WPPSS NUCLEAR PROJECT NO. 2

AMENDMENT TO FACILITY OPERATING LICENSE

License No. NPF-21
Amendment No. 16

ATTACHMENT TO LICENSE AMENDMENT NO. 16
FACILITY OPERATING LICENSE NO. NPF-21
DOCKET NO. 50-397

FIGURE 3.3.10-1

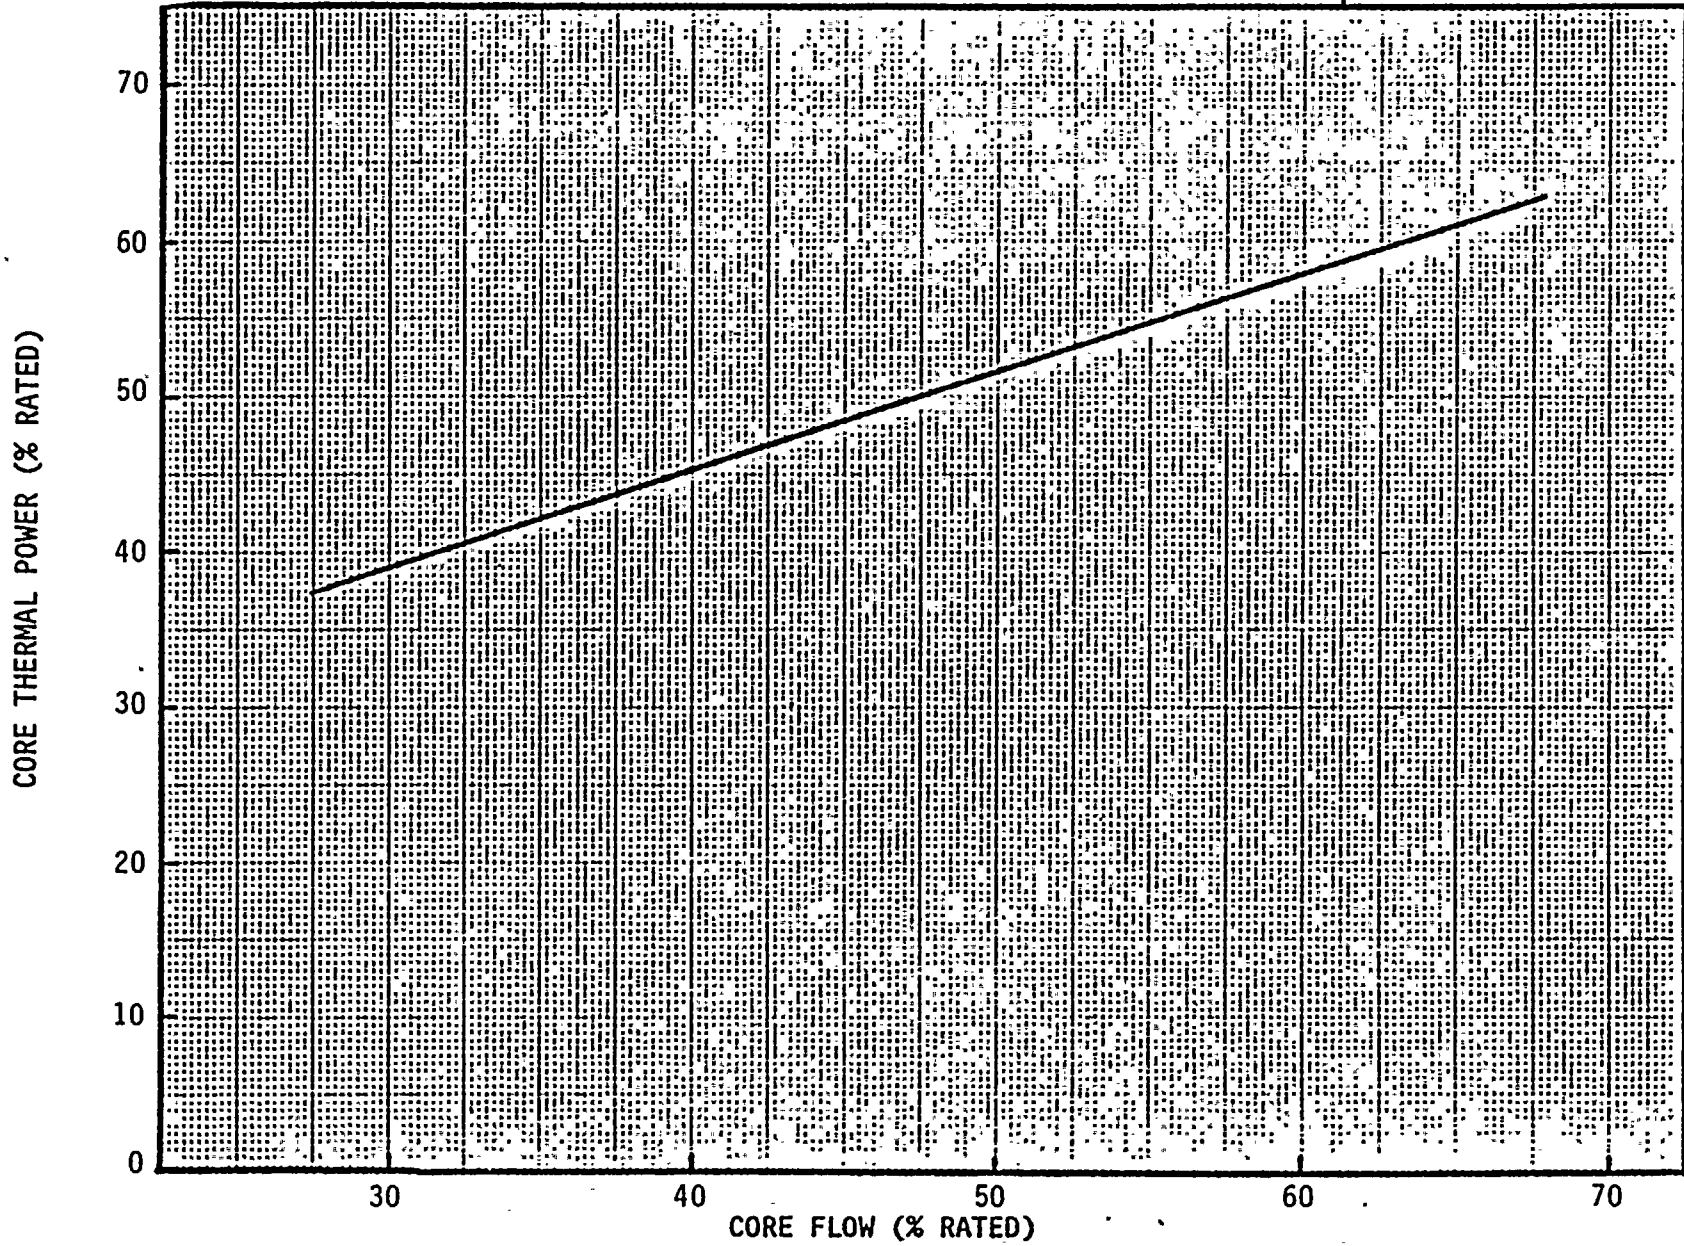
APPLICABILITY: OPERATIONAL CONDITION 1 with two reactor coolant system recirculation loops in operation with THERMAL POWER greater than the limit specified in Figure 3.3.10-1 and total core flow less than 45% of rated total core flow or with one reactor coolant system recirculation loop not in operation with THERMAL POWER greater than the limit specified in Figure 3.3.10-1.

With the APRM or LPRM* neutron flux noise level greater than three (3) times their established baseline noise levels, initiate corrective action within 15 minutes to restore the noise levels to within the required limits within 2 hours or reduce THERMAL POWER to less than or equal to the limit specified in Figure 3.3.10-1 within the next 2 hours.

4.3.10.3 With one reactor coolant system recirculation loop not in operation, establish a baseline APRM and LPRM* neutron flux noise level value with THERMAL POWER less than or equal to the limit specified in Figure 3.3.10-1 prior to entering the APPLICABLE OPERATIONAL CONDITION of Specification 3.3.10 provided baselining has not been performed with one reactor coolant system recirculation loop not in operation since the most recent CORE ALTERATION.#

3.3.10 The APRM and LPRM* neutron flux noise levels shall not exceed three (3) times their established baseline value.

FIGURE 3.4.1.1-1

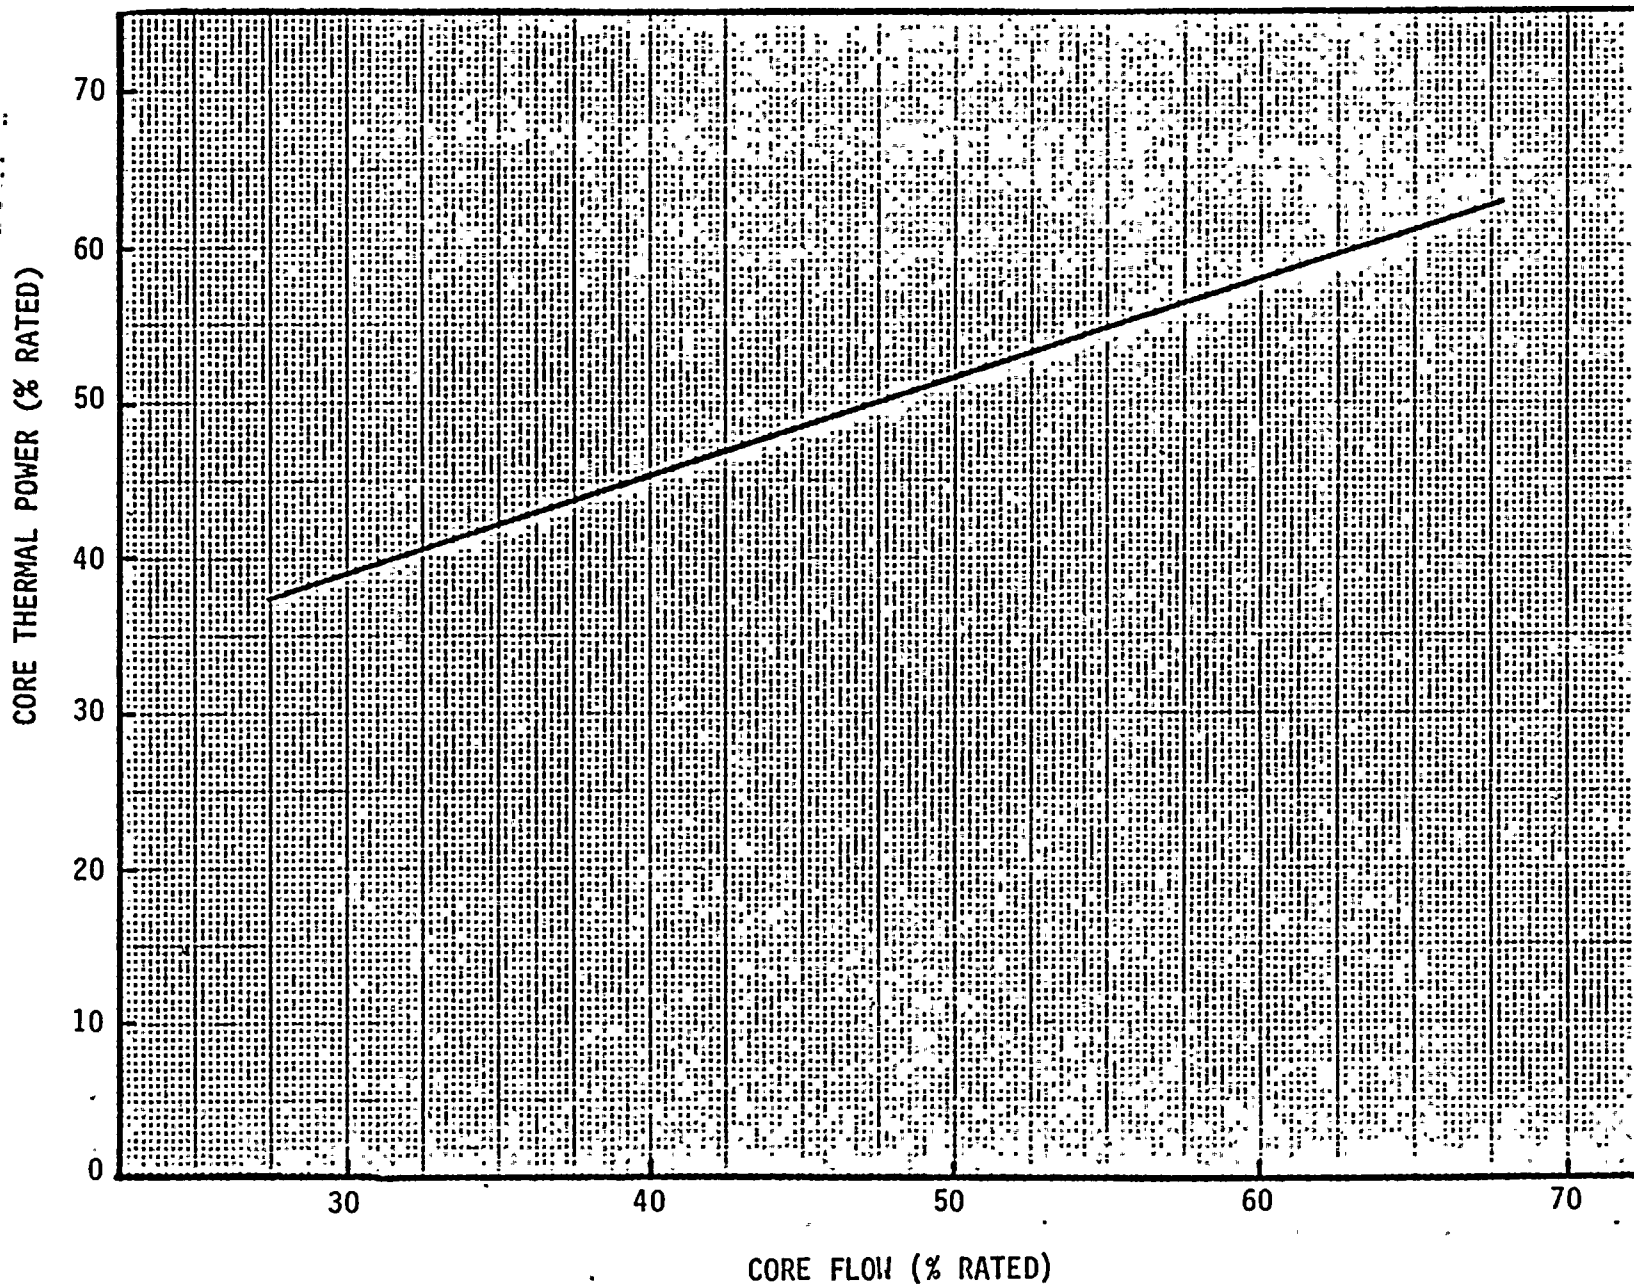
- b) The THERMAL POWER shall be less than or equal to the limit specified in Figure 3.4.1.1-1 or the provisions of Specification 4.3.10.3 are satisfied. With one reactor coolant system recirculation loop not in operation and with THERMAL POWER greater than the limit specified in Figure 3.4.1.1-1, and the provisions of Specification 4.3.10.3 having not been satisfied, initiate action within 15 minutes to reduce THERMAL POWER to less than or equal to the limit specified in Figure 3.4.1.1-1 within 4 hours. The provisions of Specification 4.3.10.3 must be satisfied prior to resuming power operation above the limit specified in Figure 3.4.1.1-1.

- i) With one reactor coolant system recirculation loop not in operation and THERMAL POWER greater than the limit specified in Figure 3.4.1.1-1 and core flow less than 39% of rated core flow, initiate action within 15 minutes to reduce THERMAL POWER to less than or equal to the limit specified in Fig. 3.4.1.1-1 or increase core flow to greater than or equal to 39% of rated core flow within 4 hours.

- c. The core plate ΔP noise is less than 200% of the established core plate ΔP noise patterns.
- d. Core flow is greater than or equal to 39% of rated core flow when core THERMAL POWER is greater than the limit specified in Figure 3.4.1.1-1.
